1. Inspection of the elevator actuator bellcrank.
2. Amendment to the Operations Manual.

All ASW 15, ASW 15 B including existing modifications into motorgliders.

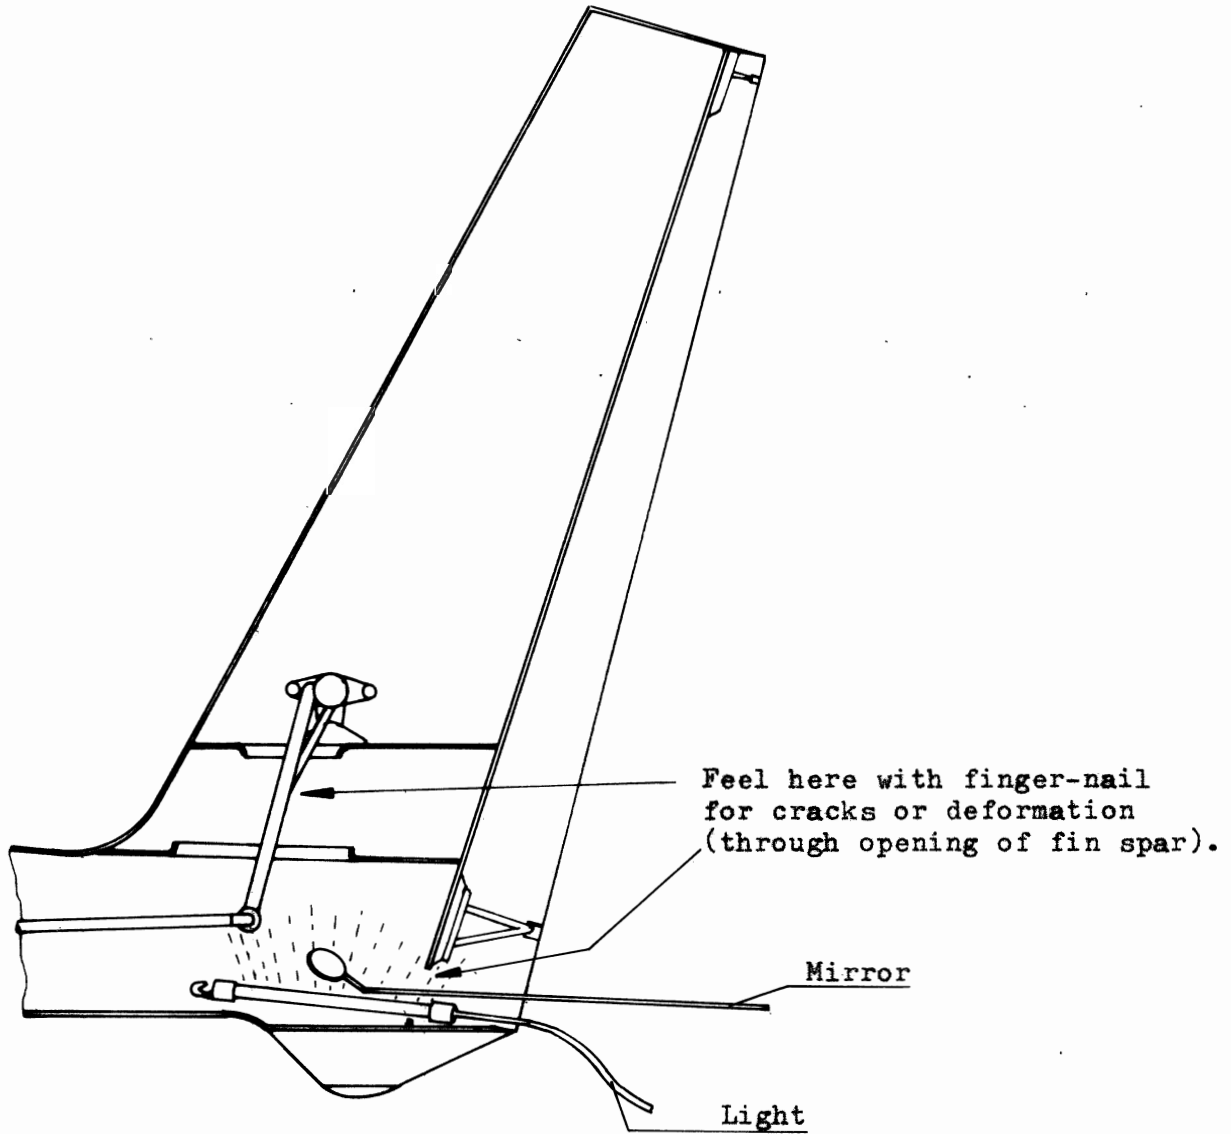
With an ASW 15 the bellcrank actuating the elevator failed in flight (see attached sketch). Luckily the pilot could save himself by parachute. An inspection of the bellcrank showed that an older crack most likely caused by a hard landing some years ago resulted in fatigue failure of the bellcrank.

1. The elevator actuator bellcrank must be inspected for cracks. To do so the rudder has to be disconnected from the fin, as the inspection is possible through a hole of the fin spar (see attached sketch). The inspection area is not directly visible. However, with the finger-nail a major crack can be felt. Smaller cracks may be found by using a mirror and a small light which is fixed to a small strip of wood or a piece of wire.  
If no cracks are found, the rudder can be rigged again to the fin and safetied.
2. If cracks are found, the bellcrank must be exchanged against a new one, i.e. a bellcrank according to drawing 151.35.1011 (showing the correction note "TM 21 dated 24-11-81"). For carrying out this job the Repair Instruction "A" for the ASW 15 is to be used.
3. A copy of the inspection report must be sent to the manufacturer.

Material : See drawing 151.35.1011 with the correction note "TM 21 dated 24-11-81".

Drawings : For this Technical Note 21 the drawings 150/151.34 M.11 \* been corrected and marked with the correction note "TM 21 dated 24-11-81".
